EMERGENCY DEPARTMENT & CANCER CENTER EXPANSION

ADDENDUM 03 11-21-07 2-25-08 ADDENDUM 05 ADDENDUM 06 4-14-08

CONTROLS, ENLARGED PLANS, SECTIONS, AND DETAILS

MF0

AHU-8 CONTROL DIAGRAM SCALE: NONE

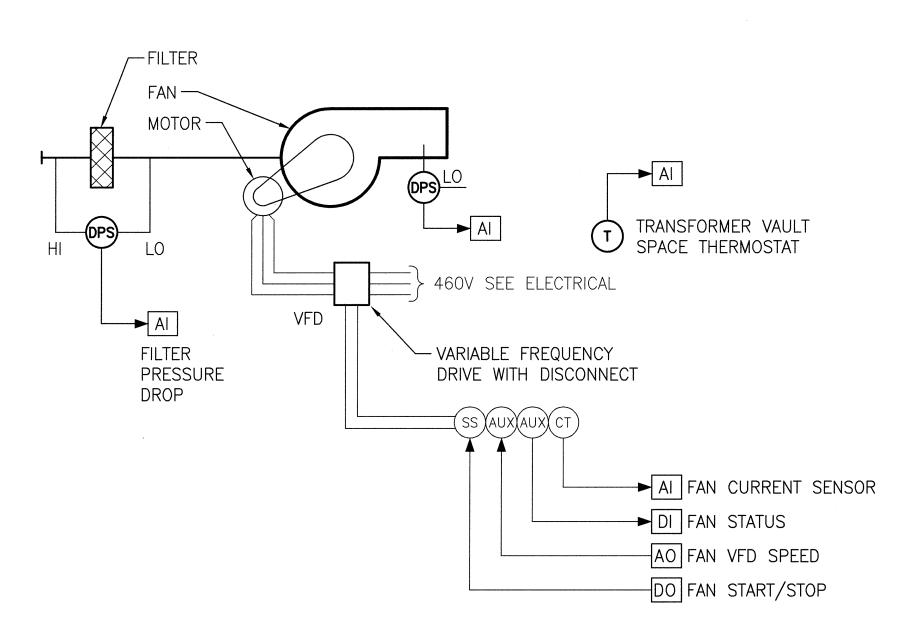
AHU-8THE ROOM THERMOSTAT THROUGH THE CAMPUS DDC CONTROLLER SHALL START THE FAN VFD WHEN THE ROOM TEMPERATURE IS 70°F (ADJUSTABLE). THE FAN STATIC PRESSURE SENSOR LOCATED IN THE FAN DISCHARGE DUCT THROUGH THE DDC CONTROLLER SHALL MODULATE THE FAN VFD TO MAINTAIN INITIAL STATIC PRESSURE SET POINT OF 0.15" W.G.

SCALE: 1/4"=1'-0"

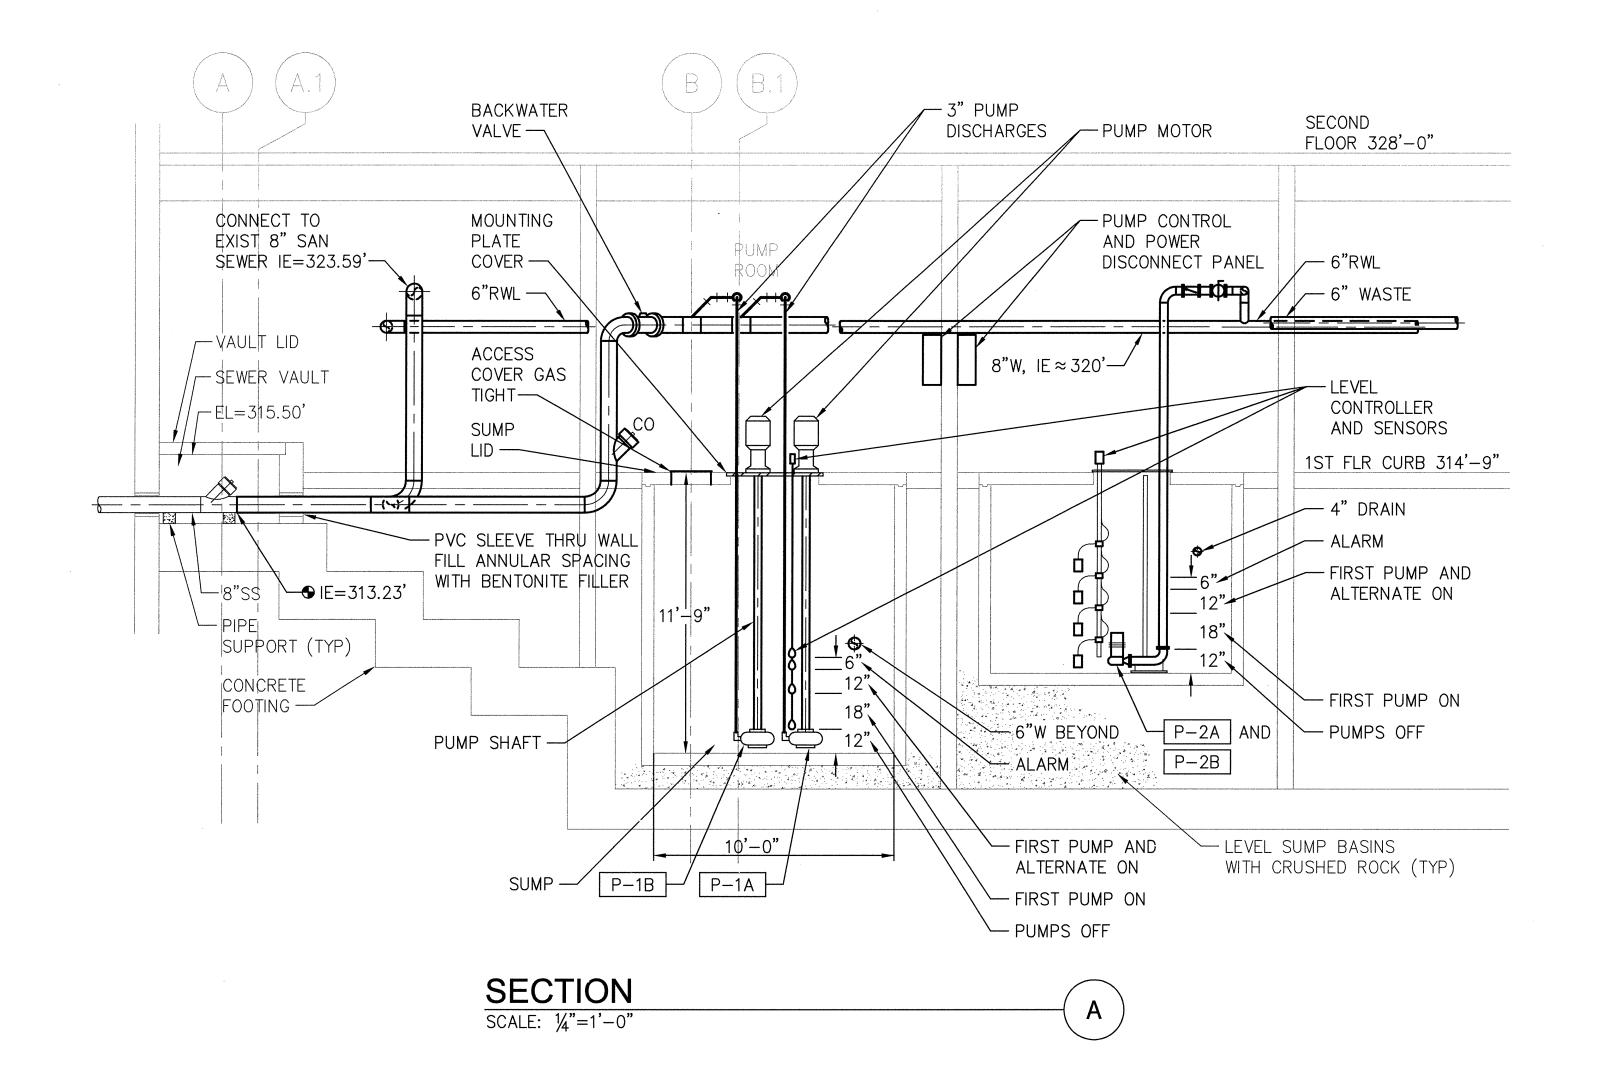
SUMP PUMPS
CONTROLS FOR SUMPS WILL BE CONNECTED TO THE BUILDING DDC SYSTEM PROVIDED AS PART OF THE ED AND CANCER CENTER EXPANSION PACKAGE.

— 4" SUMP VENT SEPARATE TO ROOF ─STORM SUMP 10'x4'x8'-6" DEEP - COVER PLATE 40x40 ACCESS DOOR LEVEL FLOATS - PUMP CONTROL PANELS WITH DISCONNECTS P-1A ─ 3" PUMP DISCHARGE (TYP) P-1B -SANITARY SUMP 10'x#'x11'-9" DEEP -PUMP COVER PLATE AND PUMP MOTOR (TYP) - BACKWATER VALVE ACCESS COVER GAS TIGHT PUMP ROOM PLAN
